UNITED STATES PATENT AND TRADEMARK OFFICE

APPLICATION NO.	FILING DATE	FIRST NAMED INVENTOR	ATTORNEY DOCKET NO.	CONFIRMATION NO.
09/516,753	03/01/2000	Gregory Pinchasik	2390/49701	3706

Office Action Summary

DETAILED ACTION

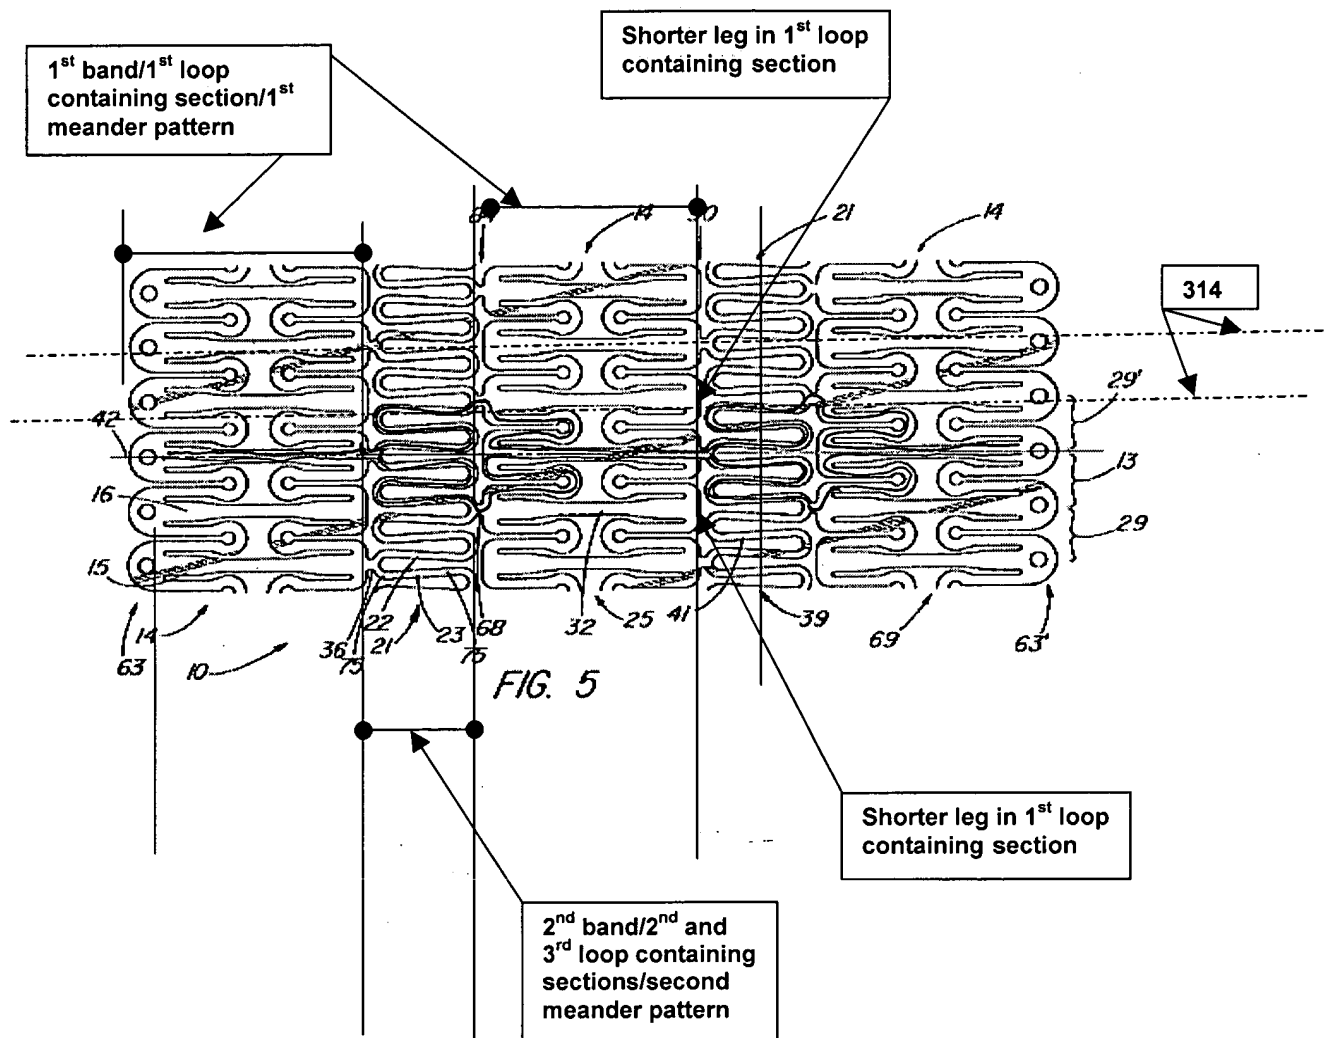
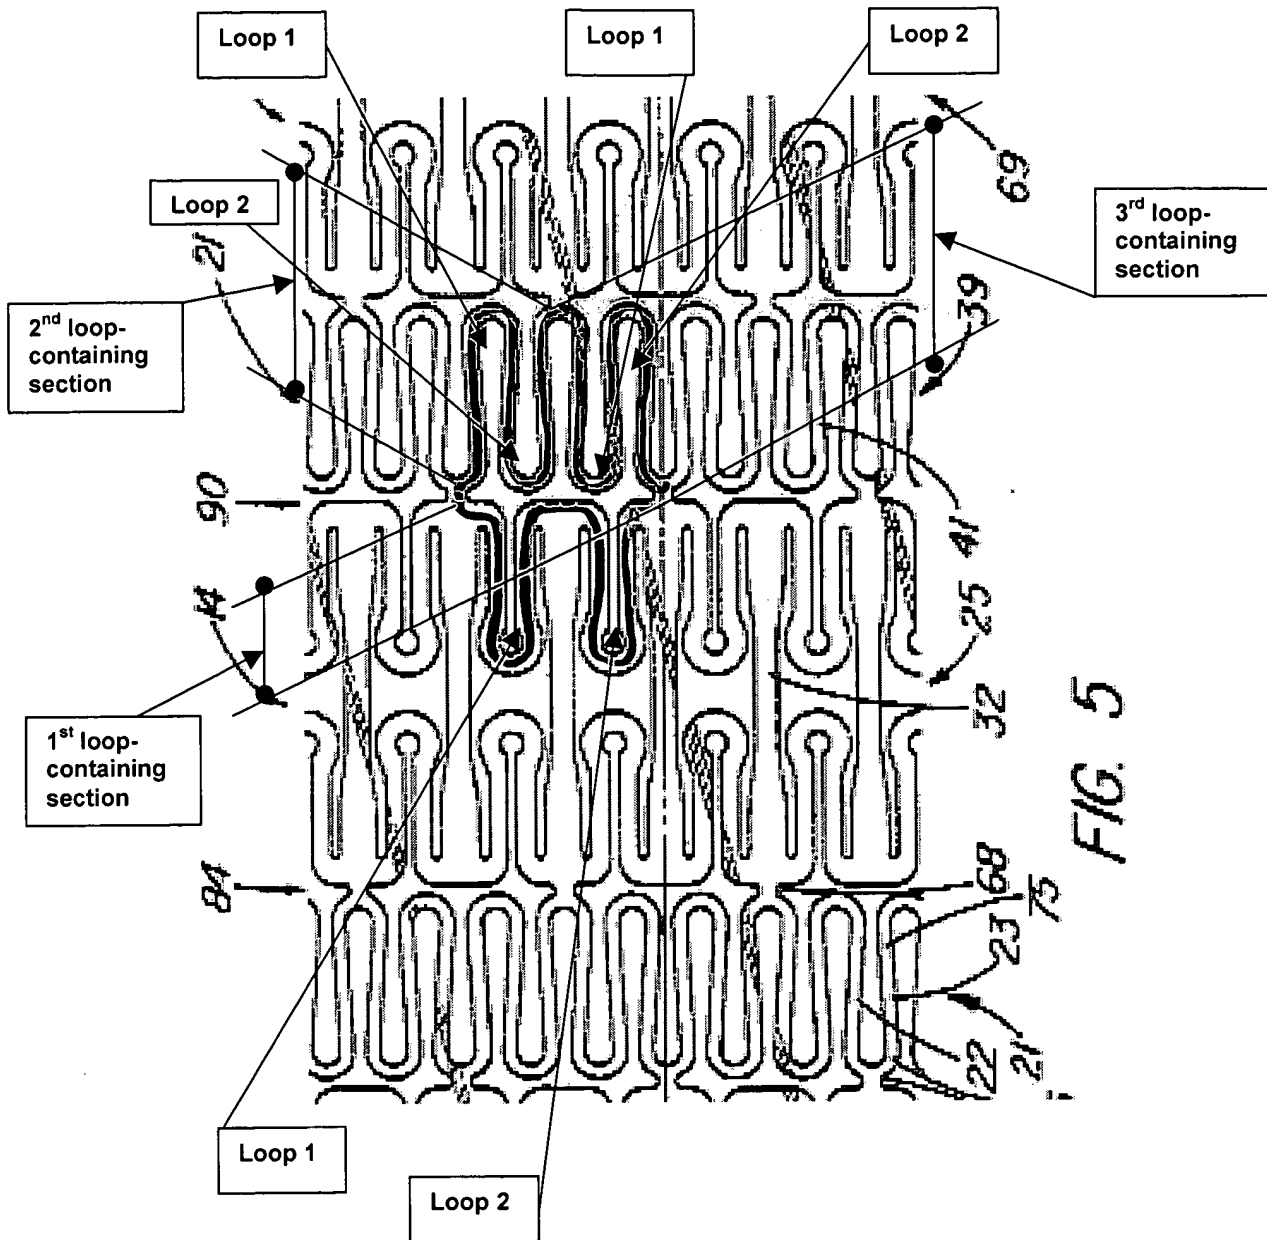
BERRY (Figs. 5 as shown below, for example) discloses a stent of stainless steel or nitinol:

As to claims 1-6 and 9-10, BERRY (Fig. 5, page 4 this paper) discloses: 1st loop-containing section (highlighted in brown), 2nd loop-containing section (green) and 3rd loop-containing section (purple). The 1st, 2nd and 3rd loop-containing sections form triangular cells (highlighted in yellow), wherein each cell covers the same area. Notice that 1st loop-containing section has wider struts than the 2nd and 3rd loop-containing section, each loop-containing section has two loops, 1st and 2nd junction points are circumferential aligned and one leg in the 1st containing section is shorter than others in the same 1st containing section. Notice that the shorter one leg in the 1st containing section changes its orientation when in an expansion condition (see Fig. 61 or 63).

As to claims 21-25, 27-33, 37-44, 46, 48-50, BERRY (Fig. 5, page 3, this paper) discloses vertical meander/first meander pattern (highlighted in red) with centerlines 301 and horizontal meander/second meander pattern (in green) with centerlines 314. The centerlines 301 of the vertical meander/first meander pattern are orthogonal to the centerlines 314 of the second/horizontal meander patterns. The vertical/first meander

(For reference to claims 95-119)

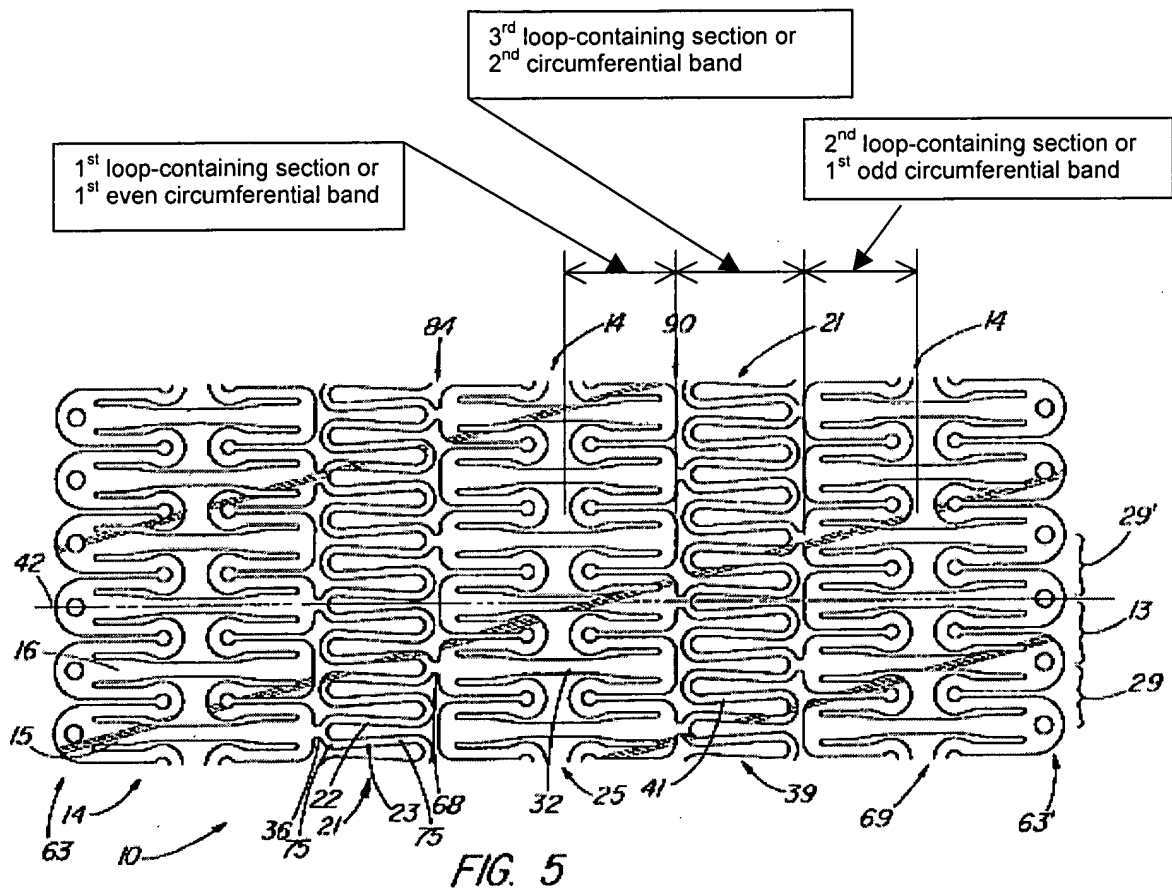
As to claims 95-102, 104, 108-114, and 116-117, BEERY (Fig. 5, also Fig. 5 on page 7, this paper) discloses an even first loop containing section 301e/first circumferential band, an odd first loop containing section 301o/first circumferential band and third loop containing section/second circumferential band disposed between the first and second loop containing sections. The first or second loop containing sections (or the first circumferential band) and the third loop containing section (or the second circumferential band) defines loops as recited in the claims.
